Donnybrook JV Pty Ltd

Expert Buffer Assessment

960 Donnybrook Road, Donnybrook

October 2020

Figure 1 Woody Hill – Extent of Operational Noise Buffers

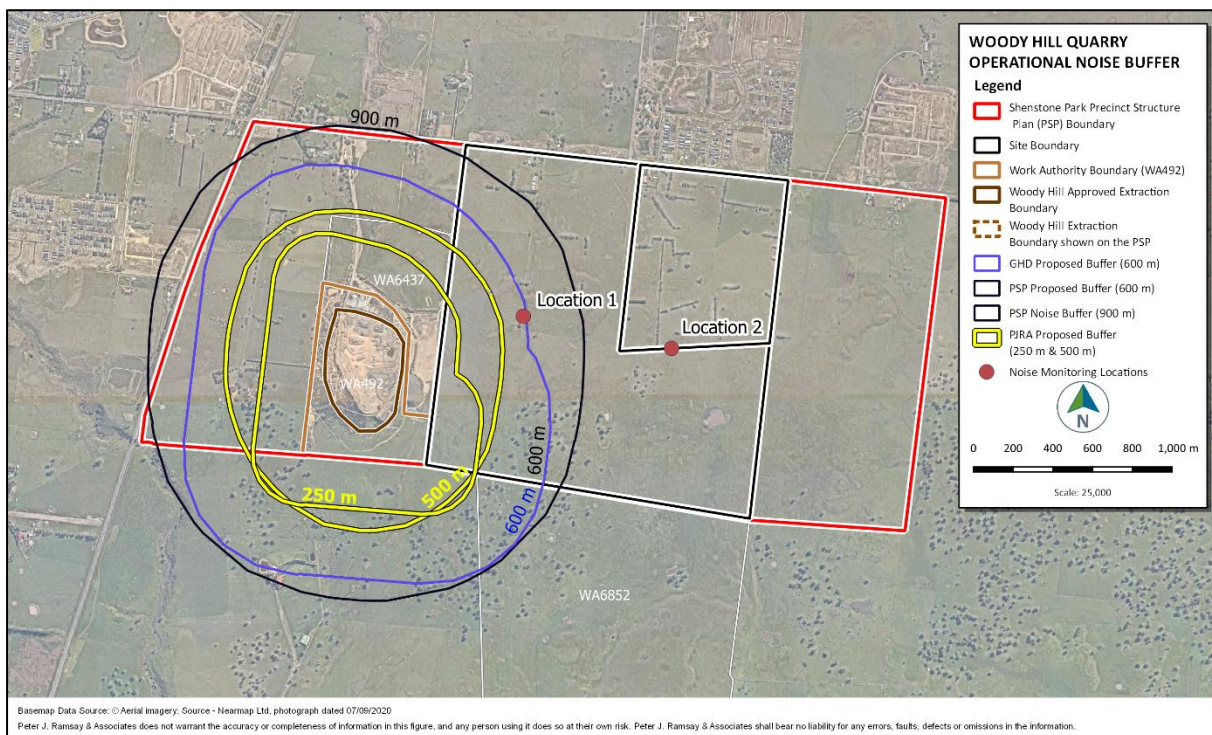
In the Impact Assessment Addendum (GHD 2019), GHD suggests an operational noise buffer for Woody Hill Quarry of 600 m from the extraction area boundary. This buffer is prior to any operational noise mitigation being implemented.

In the Impact Assessment Report (GHD 2017), GHD recommends a buffer of 900 m from the approved extraction area for the Woody Hill Quarry.

Plan 15 of the original PSP suggests an operational noise buffer of 900 m from the extraction area boundary; this buffer was not changed in Plan 15 of the revised PSP dated October 2020.

The operational noise buffers proposed by GHD and adopted in the PSP have not considered any mitigating factors such as the presence of new bunding embankments, vegetation screens or other mitigation measures. These separation distances have been modelled on incomplete information, have not been validated by field observation, are much larger than what is in place for many similar quarry operations, and have not included consultation with the quarry operator.

I note that the inputs to the noise modelling provided in the Impact Assessment Report (GHD 2017) and Addendum Report (GHD 2019) provide for elevated noise sources with no noise controls in place. The existing quarry operations from the Woody Hill Quarry could have been monitored rather than modelled. I note that some background noise monitoring was performed for preparation of the Impact Assessment Report (GHD 2017). In this report, GHD includes the following note regarding noise monitoring, "*Note that there was no Woody Hill Quarry operational noise audible at the time of GHD site visit at both monitoring locations*". This attended monitoring was performed on the 25th of August 2017.

I also note that Figure 22 of the Impact Assessment Report (GHD 2017) suggests the existing quarry operations would have approximately 15 dB(A) difference in predicted noise impact at the monitoring Location 1 and 2. Whereas, the unattended monitoring indicated a measured difference of 2 to 3 dB(A) in daytime ambient noise between the locations, according to a comparison of Tables 9 and 10 of that report.

Therefore, I consider that the acoustic modelling performed in the Impact Assessment Report (GHD 2017) is not reliable. It does not demonstrate the need for a 900 m separation distance between the existing Woody Hill Quarry extraction area and future sensitive land use.

I consider the use of the 500 m separation from the area where blasting may occur (i.e. the Approved Extraction Area within WA492) and the 250 m separation from other areas of potential quarry operation (i.e. the WA492 boundary) to be appropriate to provide protection against noise impacts. This is consistent with the buffers applied to similar quarries as discussed in Section 3.1 in this report.

Figure 2 Woody Hill – Extent of Blast Generated Vibration Buffers

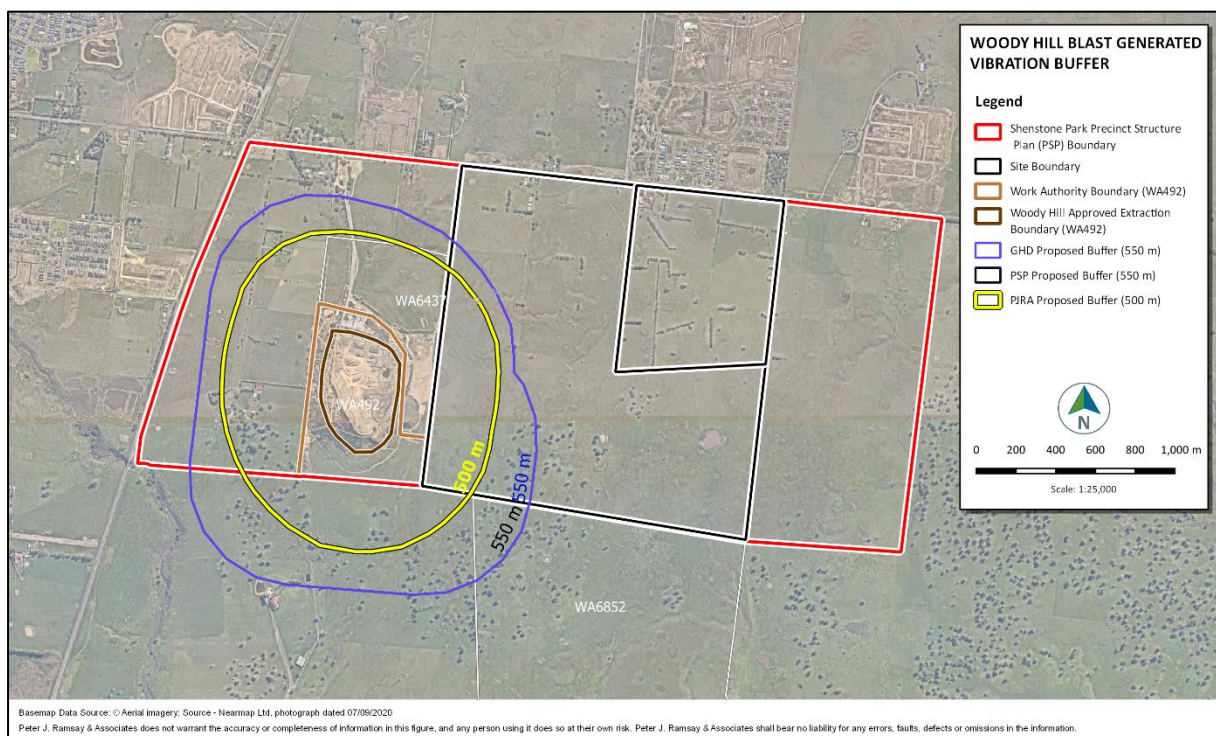
GHD recommended a 550 m buffer due to the impact of vibration on sensitive land use (GHD 2017 and GHD 2019). This recommendation was adopted in the original PSP with a sensitive use buffer for Woody Hill Quarry of 550 m from the extraction boundary.

The basis for the separation distance proposed in the GHD Impact Assessment (GHD, 2017) is a vibration assessment from a British Standard. However, GHD did not discuss whether this standard is applicable for this particular setting with regards to the geology and blasting methods. I note that the standard allows for different separation distances based on different blasting methodologies, however the operator of the quarry was not consulted regarding the planned blasting practice.

In most situations that I am aware of, the impact of vibration from quarry blasting is not known to cause adverse impact beyond the 500 m separation distance that is recommended in EPA Publication 1518 to protect against the amenity impact from dust. I understand that best practice blasting does not typically generate vibration impacts beyond 500 m from the extraction area.

I consider the use of the 500 m buffer from an area where blasting may occur, as provided for control of dust impact in EPA Publication 1518, to be appropriate to provide protection against vibration impacts. This is consistent with the buffers applied to similar quarries as discussed in Section 3.1 of this report.

Figure 3 Woody Hill – Extent of Blast Generated Dust Buffers

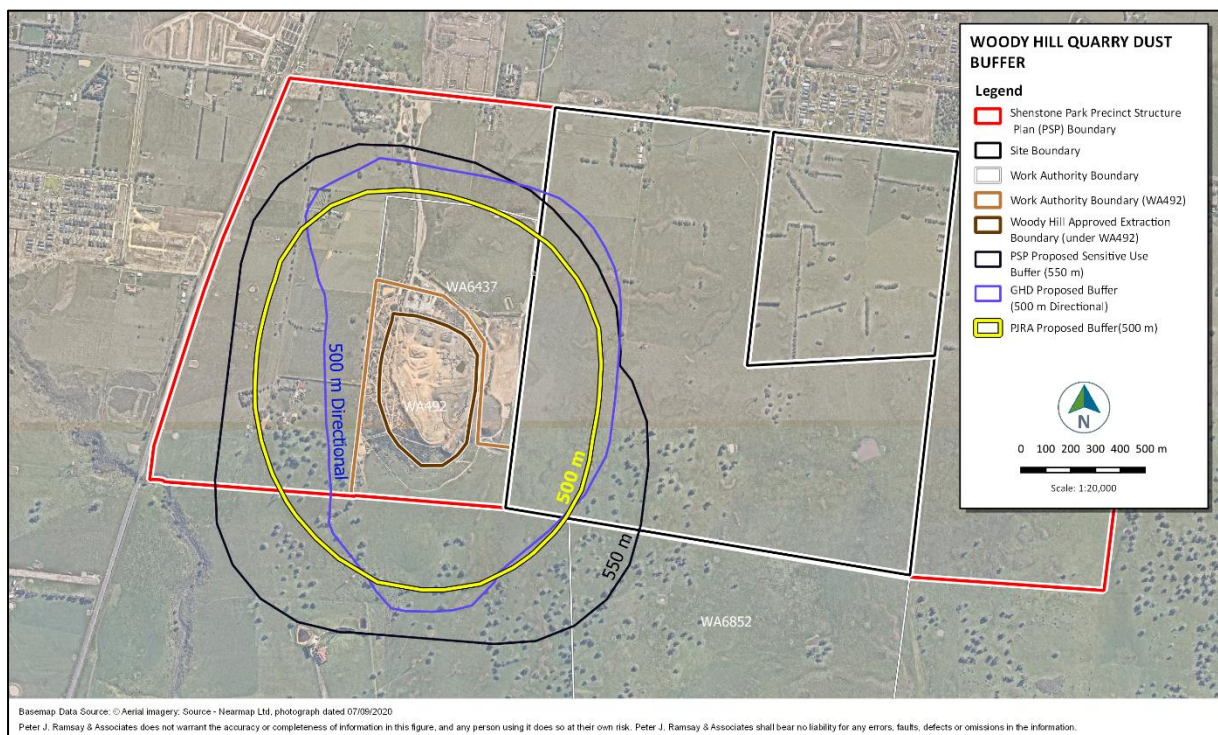
The PSP provides a 550 m buffer from the outer extent of the area marked “Woody Hill possible extraction expansion” on Plan 15 of the PSPs to protect against dust impacts from the quarry operations. I assume that this is intended to provide protection against blasting activities and other quarry activities at the Woody Hill Quarry.

GHD (2019) recommends using a 500 m directional buffer to protect against dust impacts from quarry operations. The buffer is proposed to extend more than 500 m east of the Work Authority Boundary.

I consider the use of the 500 m buffer from an area where blasting may occur, as outlined in EPA Publication 1518, to be appropriate to provide protection against dust for more sensitive uses. There is no justification for the use of a directional buffer, therefore this should be a linear separation distance from the outer extent of the Approved Extraction Area on WA492. This is recommended in EPA Publication 1518 and is consistent with the buffers applied to similar quarries as discussed in Section 3.1 of this report.

Figure 4 Woody Hill – Blast Generated Fly-Rock Buffers

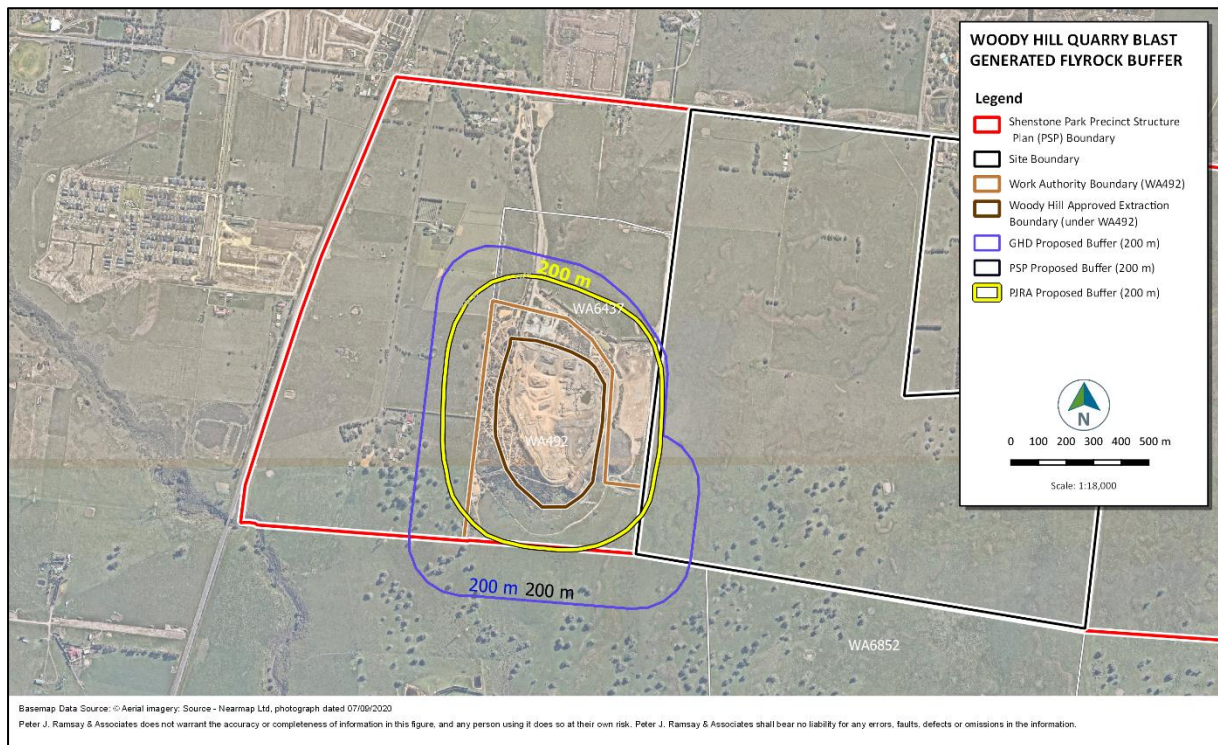
I consider the use of a 200 m buffer from the proposed extraction area to be appropriate to provide protection against blast generated fly-rock impacts. This is consistent with the buffers provided to similar quarries as discussed in **Section 3.1** of this report.

Figure 5 Woody Hill Expansion – Extent of Operational Noise Buffers

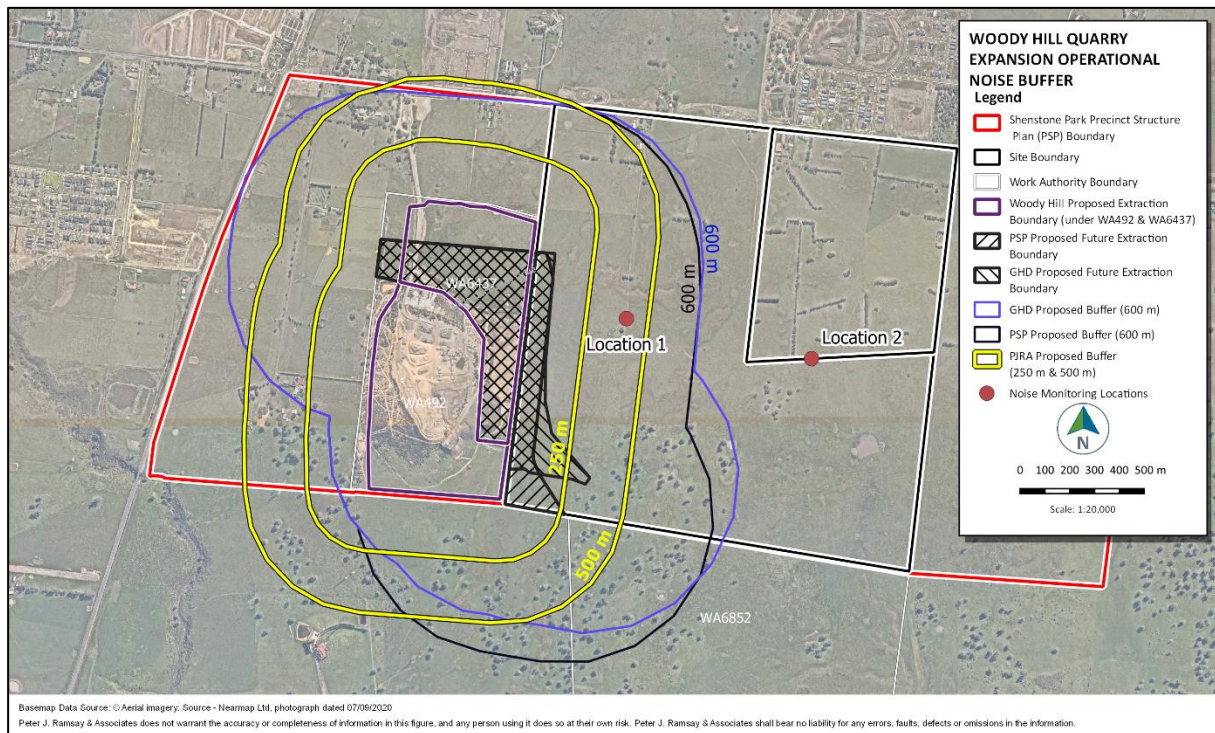
GHD (2019) recommends an operational noise buffer for the Woody Hill Expansion of 600 m from the possible extraction area boundary. The original PSP also adopts the operational noise buffer of 600 m from the possible extraction area boundary.

As discussed in **Section 5.2.1**, I consider that the methodology for assessing the extent of the separation distance is flawed. As also discussed in **Section 5.2.1**, I consider the adoption of a 250 m buffer from the outer boundaries of the land subject to WA492 and WA006437 appropriate to provide protection against noise impacts.

Figure 6 Woody Hill Expansion – Extent of Blast Generated Vibration Buffers

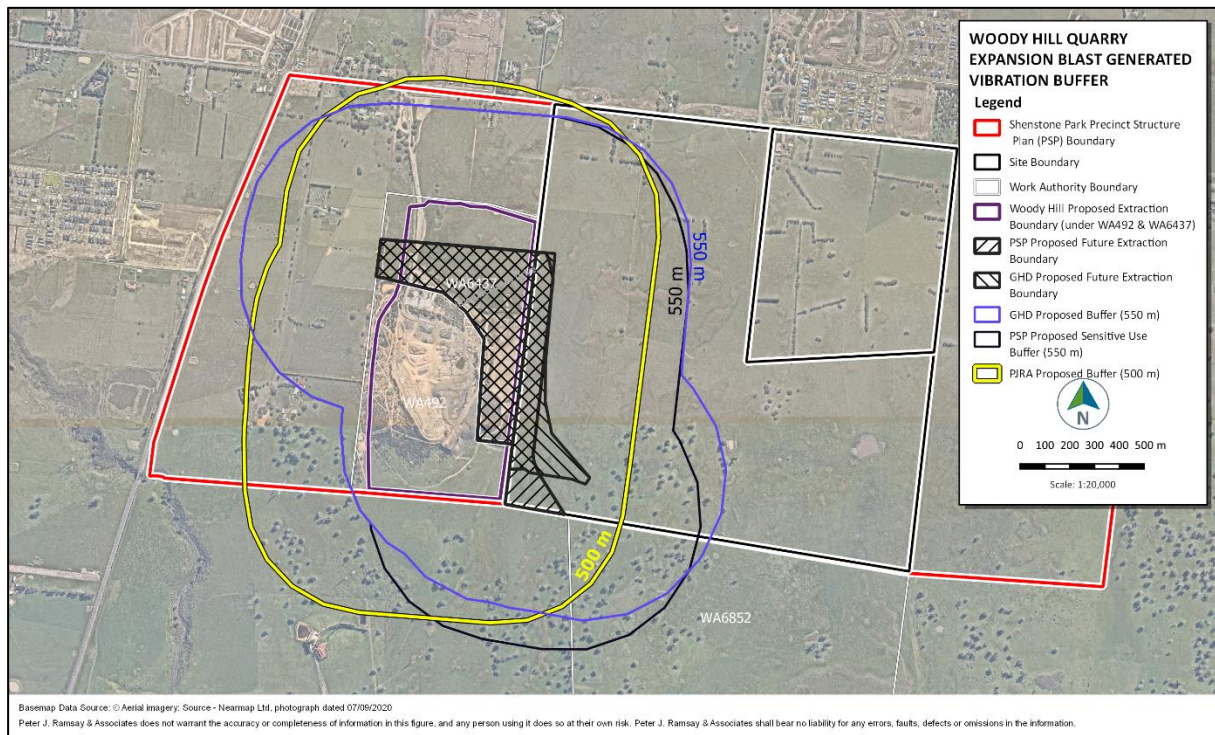
As discussed in **Section 5.2.1**, I consider that a separation distance of 500 m from the proposed extraction areas on the land subject to WA492 and WA006347 appropriate to protect sensitive receptors from vibration due to blasting.

Figure 7 Woody Hill Expansion – Extent of Blast Generated Dust Buffers

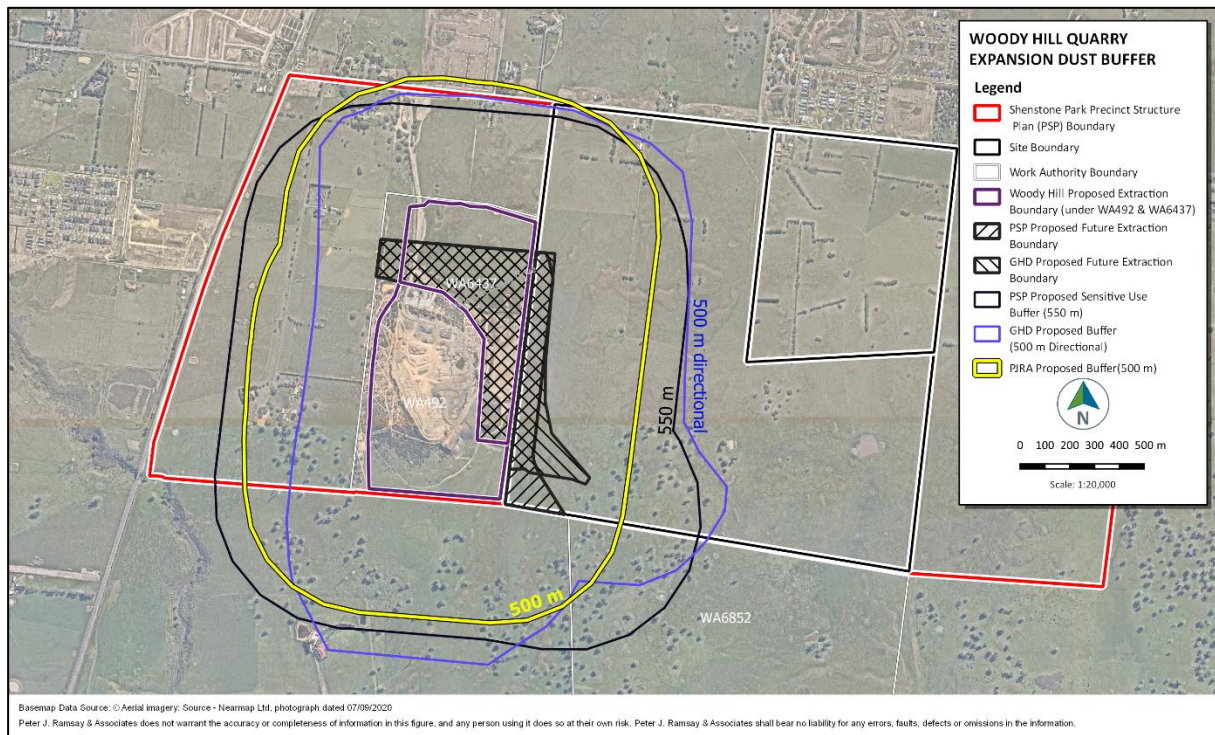
As discussed in **Section 5.2.1**, I consider that a separation distance of 500 m from the proposed extraction areas on the land subject to WA492 and WA006347 is appropriate to protect sensitive receptors from vibration due to blasting.

Figure 8 Woody Hill Expansion – Extent of Blast Generated Fly-Rock Buffers

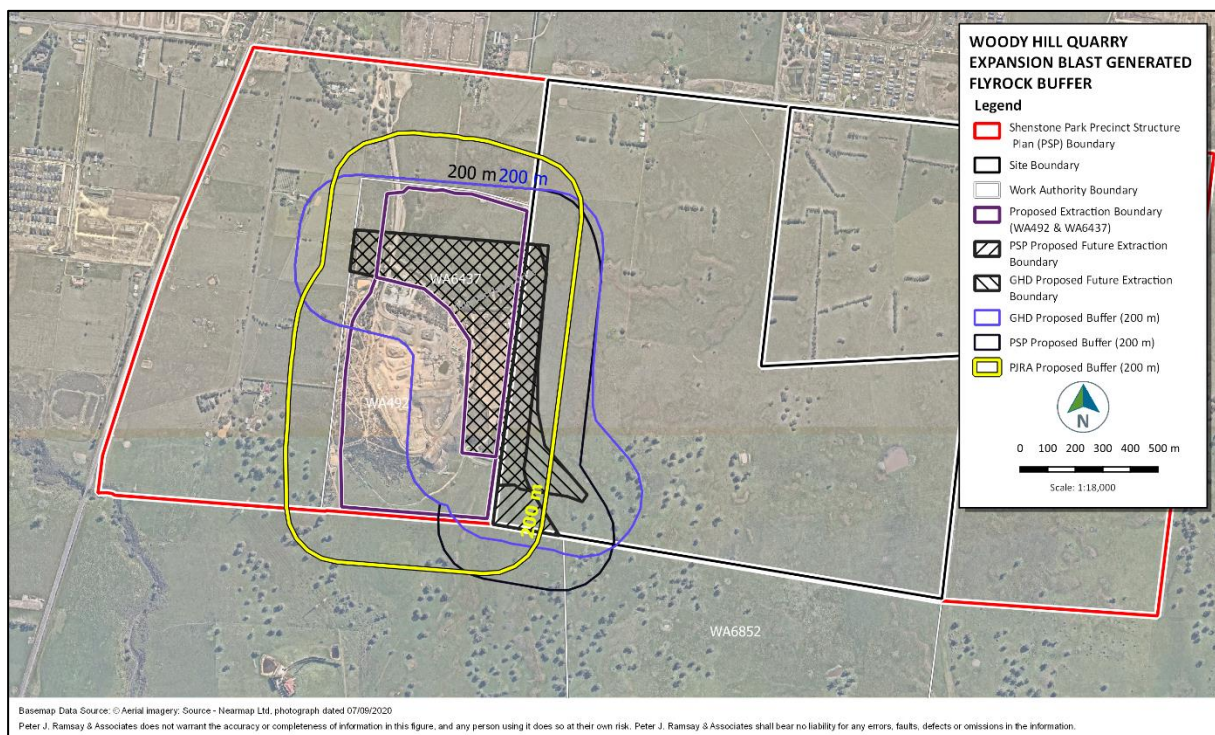
GHD (2017) recommends a 200 m separation distance for protection against blast generated fly-rock. This was adopted in Plan 15 of the original PSP dated September 2019 and retained in Plan 15 of the revised PSP dated October 2020.

I consider the adoption of a 200 m buffer from the proposed extraction boundary within WA492 and WA006437 to be appropriate to provide protection against blast generated fly-rock impacts.

Figure 9 Phillips Quarry – Extent of Operational Noise Buffers

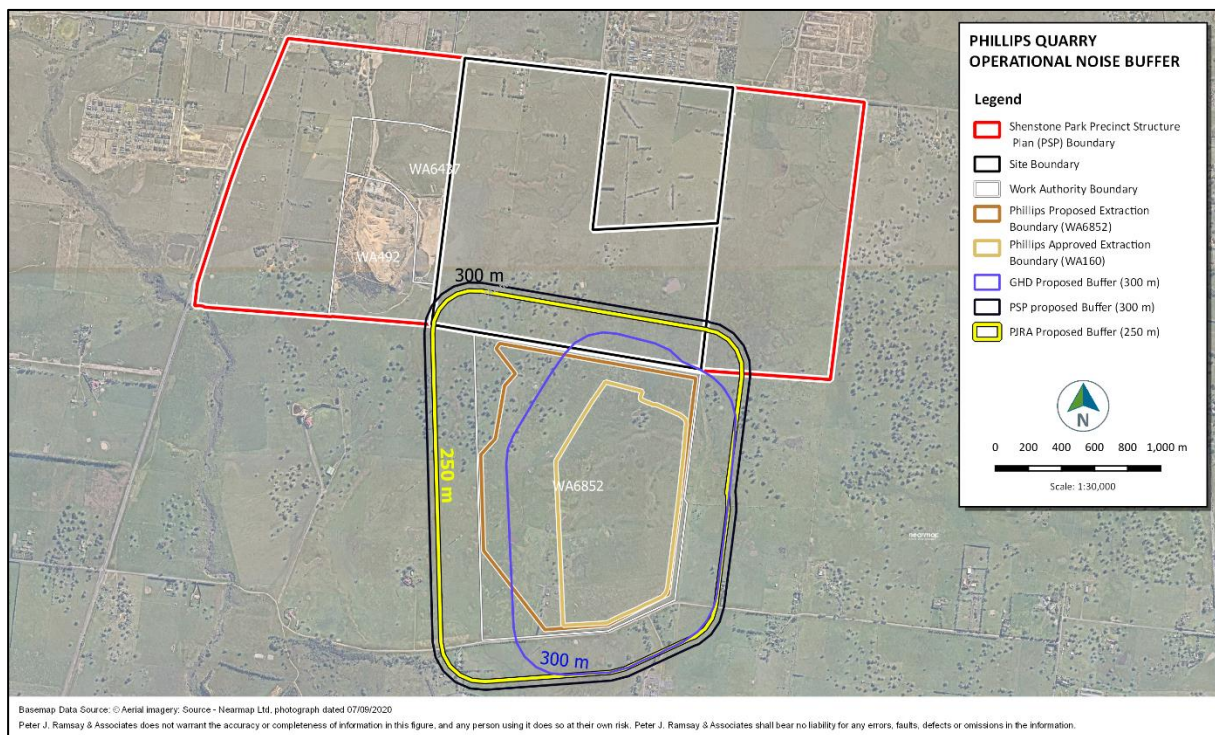
GHD (2017) recommends an operational noise buffer from the proposed Phillips Quarry of 600 m from the proposed extraction boundary.

The PSP adopted a noise buffer for the proposed Phillips Quarry of 300 m from the proposed works authority boundary.

The same methodology was used to assess the future impact of the Phillips Quarry as was used to assess the potential noise impact from the Woody Hill Quarry and Woody Hill Quarry Expansion. As discussed in **Section 5.2.1**, a 250 m separation from areas of the quarry operations and 500 m separation from the proposed extraction area for the Phillips Quarry, are appropriate to provide protection against noise impacts.

Figure 10 Phillips Quarry – Extent of Blast Generated Vibration Buffers

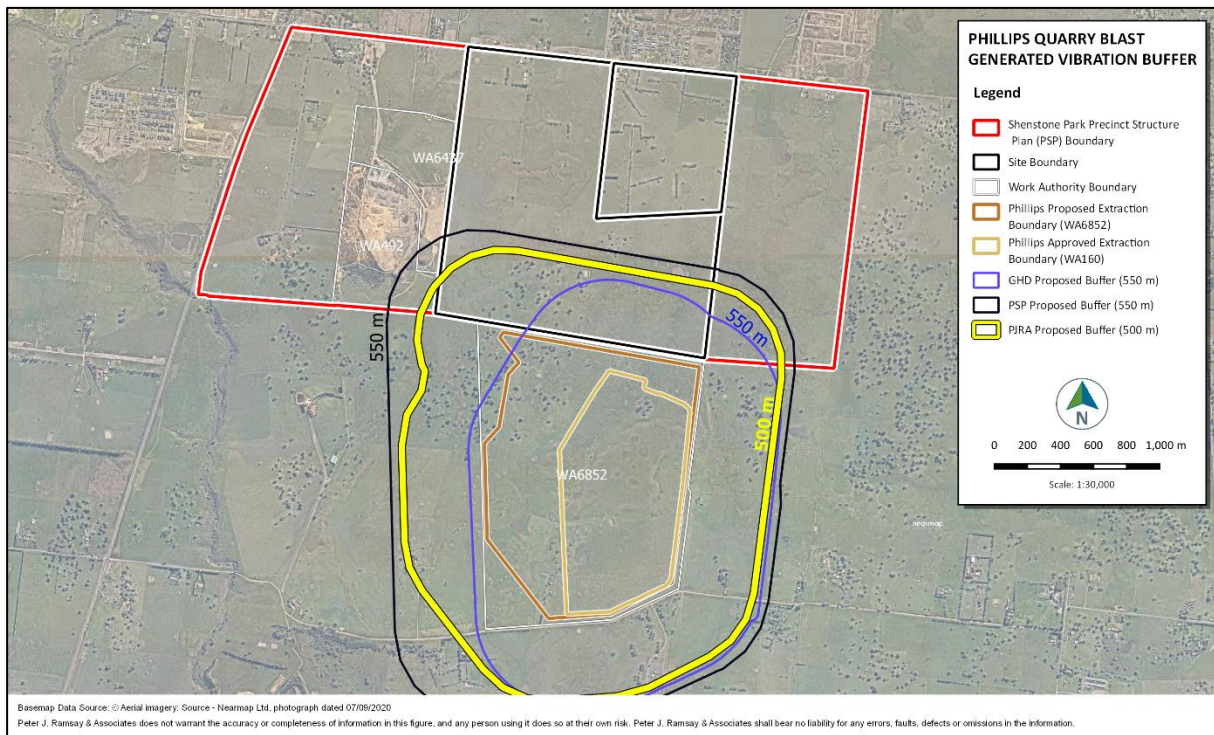
GHD (2019) recommends a blast generated vibration buffer from the proposed Phillips Quarry of 550 m from the approved extraction boundary.

The PSP adopts this under the sensitive land use buffer from the proposed Phillips Quarry of 550 m from the proposed works authority boundary.

For the reasons discussed in section 5.2.4 of this report, I consider the use of a 500 m buffer from the approved extraction boundary to be appropriate to provide protection against blast generated vibration impacts.
